SERVICE BULLETIN

| Reference number: | SB-01-1360 | Issued: 3 February, 2020 |
| Subject: | Intermittent Key Operation | |
| Model(s): | DB11, Vantage 19MY | |

Figure 1

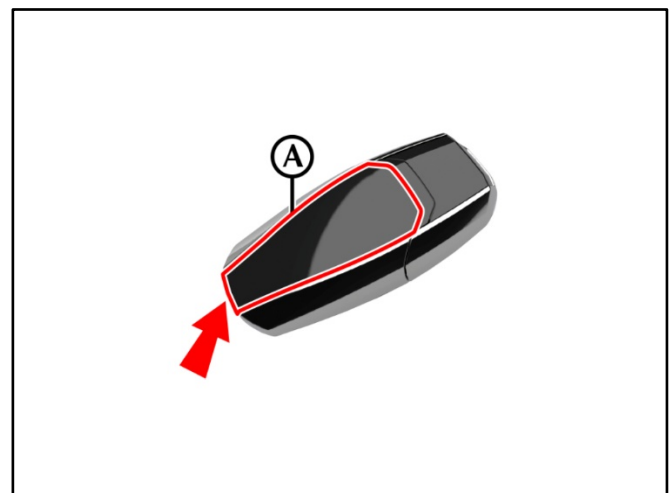
There have been problems with some vehicle keys where they cannot unlock the vehicle. The cause is the battery connection in the vehicle key, which can fail intermittently. To correct this problem, a larger battery (Panasonic CR2032) is now used. Do the workshop procedure that follows to change the battery.

1. Lift the battery cover (refer to A, Figure 1).

Figure 2

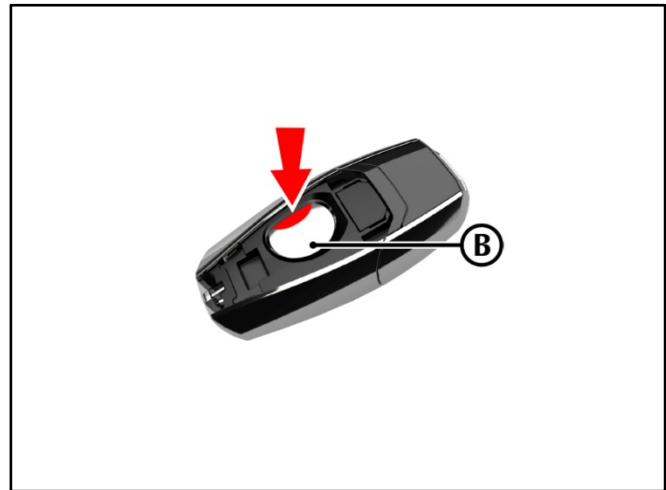
2. Push down on the battery to tilt the battery and allow access (refer to B, Figure 2).

3. Remove the battery.
4. Install a new battery (Panasonic CR2032). Make sure the (+) sign points up.
5. Install the battery cover.
